October 13, 2023

**Re: Bethlehem Landfill Phase V Expansion – Land Use of Regional Significance
Lower Saucon Township
Northampton County**

Act 167 Drainage Plan Review

Re: Bethlehem Landfill – Phase V Expansion
Plans Dated September 11, 2023
Lower Saucon Township
Northampton County

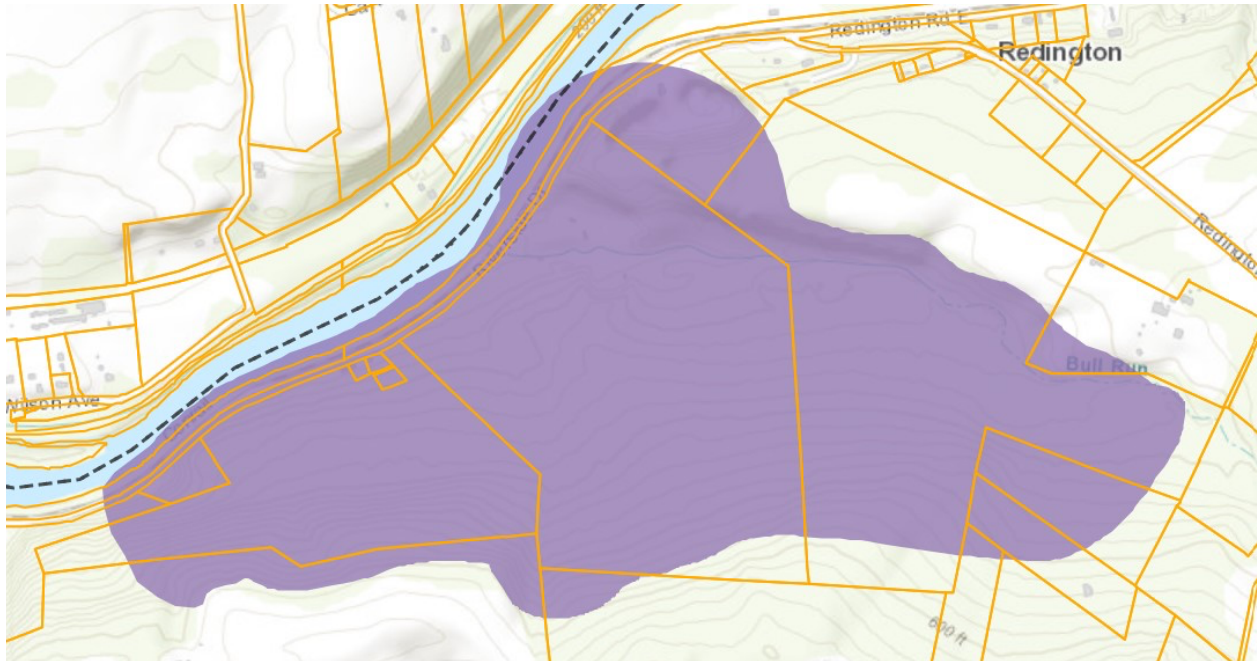
While the area of the landfill currently in operation is located within the Development area of the General Land Use Plan of *FutureLV: The Regional Plan*, the proposal conflicts with *FutureLV* because most of the area proposed for expansion of the landfill to the northeast is within a Character-Defining area of the General Land Use Plan, representing the natural and scenic character of the Lehigh Valley.
